Commission of Architectural Review

10. COA-166145-2025	Final Review	Meeting Date: 5/27/2025
Applicant/Petitioner	Kathryn Miller	
Project Description	Replace fourteen non-original windows with new composite wood windows.	
Project Location		
Address: 3118 E Broad Street, Richmond, VA 23223		
Historic District: St John's Church		
<p>High-Level Details:</p> <p>The applicant proposes to replace 14 existing windows at 3118 E. Broad Street with new composite windows made of "Fibrex" material. The property is a contributing structure in the District, and historic photographs show that the structure has undergone numerous alterations, including possible changes to window opening sizes and cladding (original window configuration was 6-over-6 double-hung wood sash windows, and the original façade material was modified from stucco to siding).</p> <p>As the applicant proposes to introduce a composite window material, staff has requested a sample of the proposed window to assess compatibility.</p>

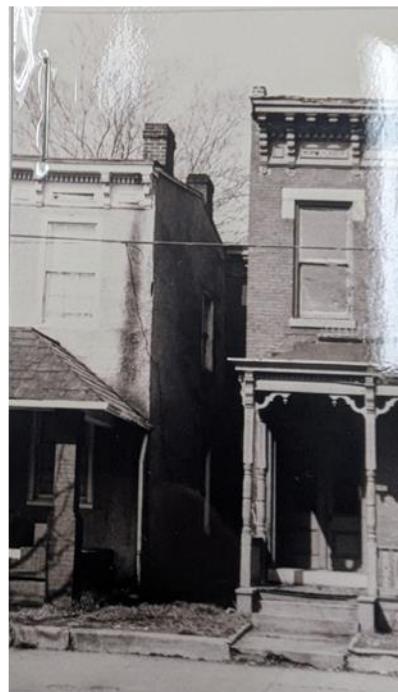
Building Elements, Windows, pg. 69	<p><i>The architectural character of windows should not be altered by inappropriate materials or finishes that radically change the sash, depth of reveal, muntin configuration, the</i></p>	<p>The proposed casement operation does not match the vertical double-hung rhythm seen on this block (Figure 4Figure 3). Additionally, casements can potentially introduce large unbroken glass planes inconsistent with the vertical orientation of neighboring double-hung windows.</p> <p>The application proposes one casement window to be placed in the kitchen (Figure 3). It is possible that this particular window would not be visible from the public right-of-way, and be concealed by the fence and neighboring structures, as seen in Figure 4. If this visual screening is</p>

<i>reflective quality or color of the glazing or the appearance of the frame.</i>	<p>confirmed, staff finds that a single, non-visible casement window may be acceptable as a functional exception, particularly if located at the rear or side where it does not impact the building's historic street-facing presentation.</p> <p><u>Staff recommends that the applicant verify the placement and visibility of the proposed kitchen casement window.</u></p> <p><u>If it is confirmed that the window is not visible from any public right-of-way, staff supports its approval as an exception due to its minimal visual impact and location on a non-primary elevation.</u></p> <p><u>If the window is visible, staff recommends replacing it with a double-hung window, consistent with the rest of the façade, to maintain visual continuity with the district</u></p>
Building Elements, Windows, pg. 69	<i>The number, location, size or glazing pattern of windows should not be changed by cutting new openings, blocking out windows or by installing replacement sash that do not fit the original window.</i>	<p>The main elevation of the building features a continuous frieze board above the windows that aligns directly with their widths. Any change in window width would disrupt this historic visual rhythm. <u>Staff recommends that replacement windows should match existing widths exactly to preserve the frieze-window alignment.</u></p>

Staff Recommendations	<p>Staff recommends the following:</p> <ul style="list-style-type: none"> Given the difficulty in reconstructing the original 6-over-6 windows, staff recommends installing replacement double-hung 1-over-1 sash windows that match the current form and district context Maintain the exact width of all existing window openings to preserve the relationship with the frieze board Verify the location of the kitchen window; <ul style="list-style-type: none"> if it is not visible from any public right-of-way, staff supports its replacement with a casement window. if the window is visible, staff recommends replacing it with a double-hung window.
-----------------------	-----------------------------------------------------------------------------------------------------------------------------------------------------------------------------------------------------------------------------------------------------------------------------------------------------------------------------------------------------------------------------------------------------------------------------------------------------------------------------------------------------------------------------------------------------------------------------------------------------------------------------------------------------------------------------------------------------------------------------
